MEMORANDUM

SUBJECT: Consider Approval of Design Review for a Proposed Chick-fil-A at 3035 White Bear Avenue

Engineering Plan Review

PROJECT: **Chick-Fil-A**
PROJECT NO: **16-03**

SHEET TITLE
SITE PLAN

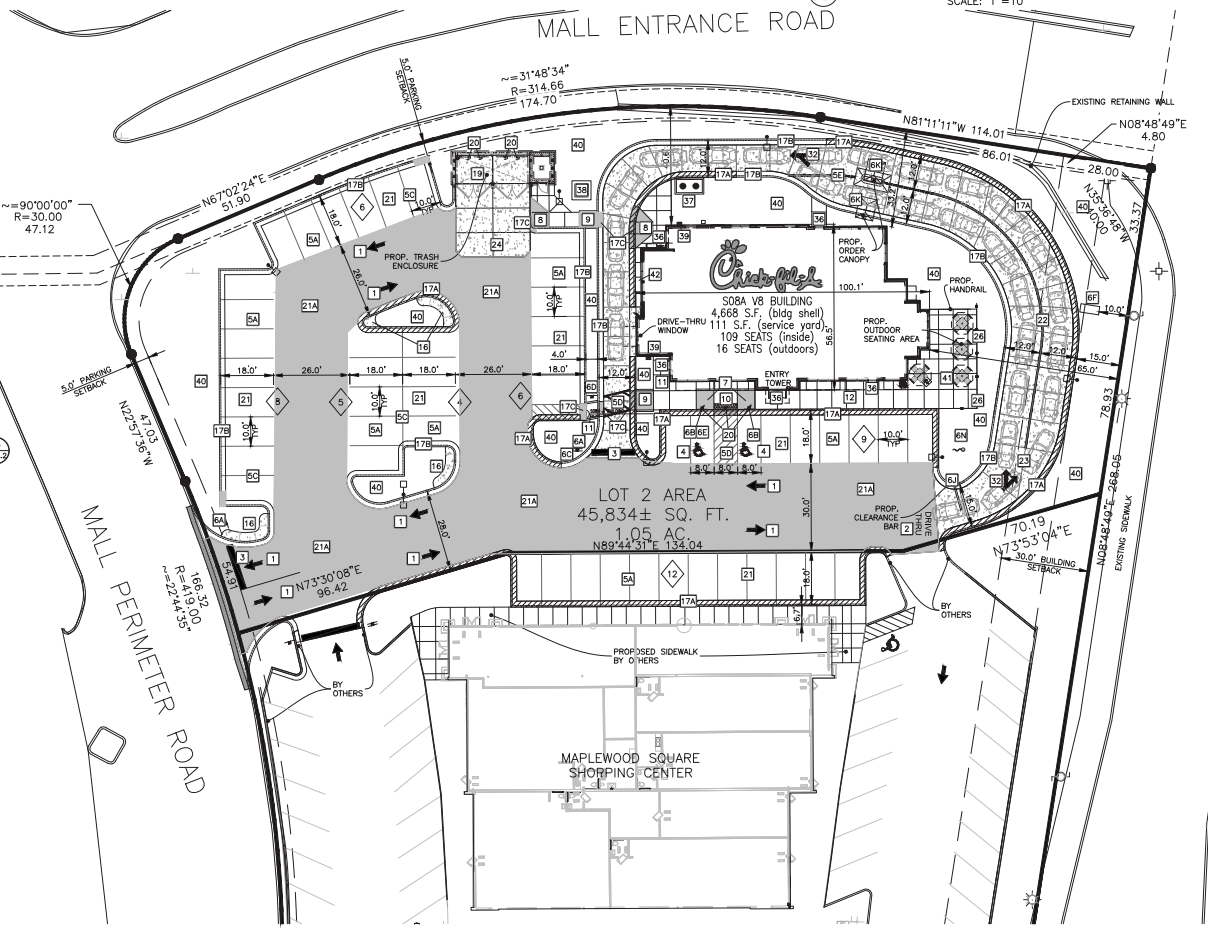
The proposed freestanding sign would be 20 feet in height which meets the height requirement and the size itself would be 76 square feet which is less than the maximum allowed (140 square feet). Staff is recommending the applicant submit a revised site plan showing the sign meeting the city’s 25 foot site triangle requirements. The proposed menu boards on site meet all ordinance requirements.

4. Prior to issuance of a grading or building permit, the applicant shall submit a revised site plan showing the placement of the freestanding pylon sign which would meet the city's site triangle requirements.

4) Emergency overland overflows shall be identified on the plans for the underground infiltration system.

11) The total grading volume (cut/fill) shall be noted on the plans.
